Application for Downtown/Riverfront (D/R) Overlay Permit
Staff Report

CASE: DRO-24-16

Applicant:	W2B, LLC
Meeting Date:	December 9, 2016 (ARC)
Received by:	Will Smith
Submission Date:	November 18, 2016
Property Address:	1121 22nd Avenue
Zoning:	BGO
Permits Required:	LDP and Building Permit
Nature of Project:	New Construction of Townhomes

Project: 12th And 22nd Townhomes

EXTERIOR ELEVATIONS

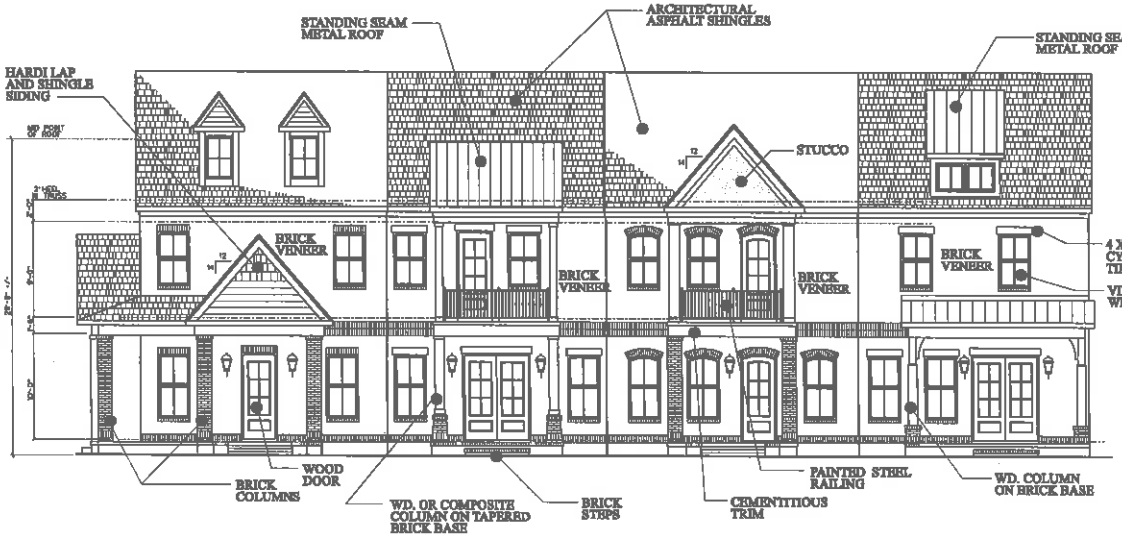
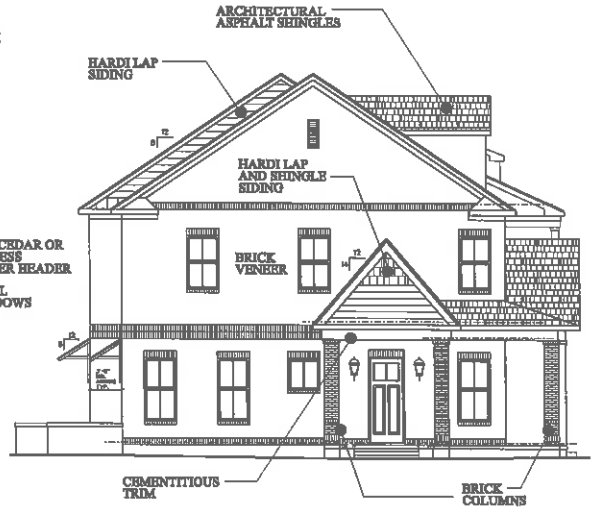
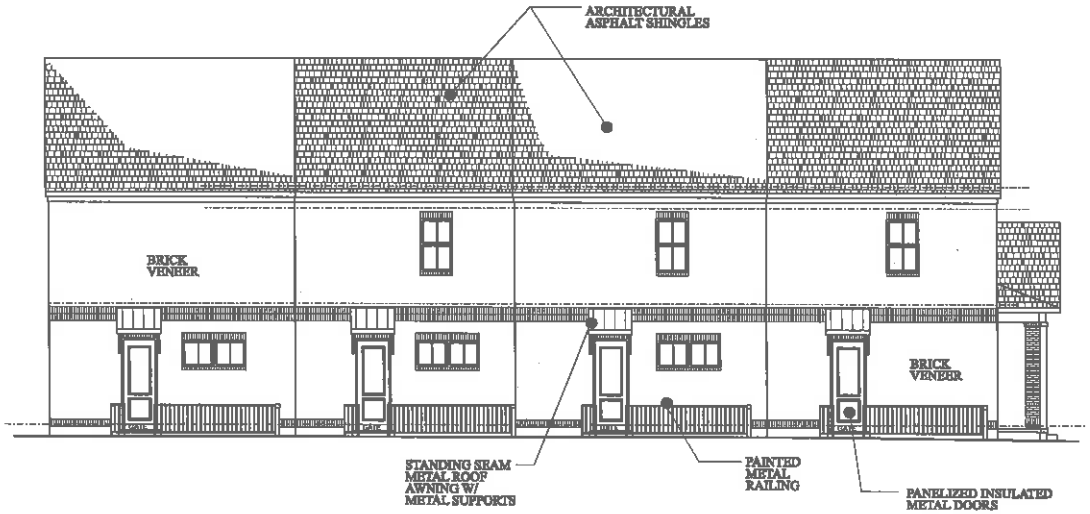
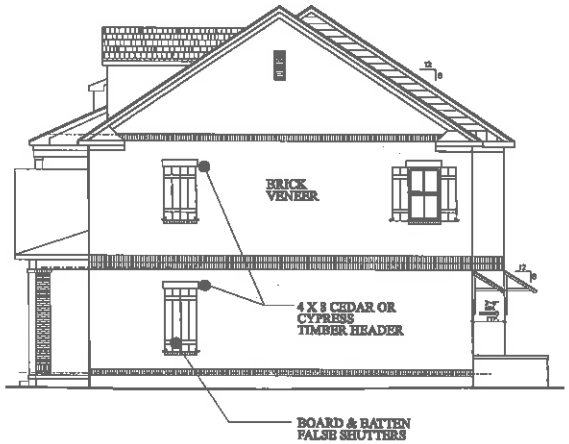
The proposed building is devoting much of the street-facing ground floor building façades to transparent windows, as per Sec. 24-230(b)(1)(i) of the zoning ordinance. The 12th Street façade will feature 30% transparency, the stated minimum. However, the 22nd Avenue façade will only feature 21%. The slight deviation is due to the proposal's residential use. Commercial continuity will be maintained along both streets as there are no parking lots, curb cuts, or blank walls [Sec. 24-230(b)(2)(c)]. The mechanical equipment is proposed to be screened by the building itself [Sec. 24-230(b)(7)(f), (g)]. The proposal plans to use city issued garbage carts, and they will be stored behind the building when not on the street for pick up.

The Committee discussed brick color variation. They wanted to know if the townhomes would all be the same color brick or not.
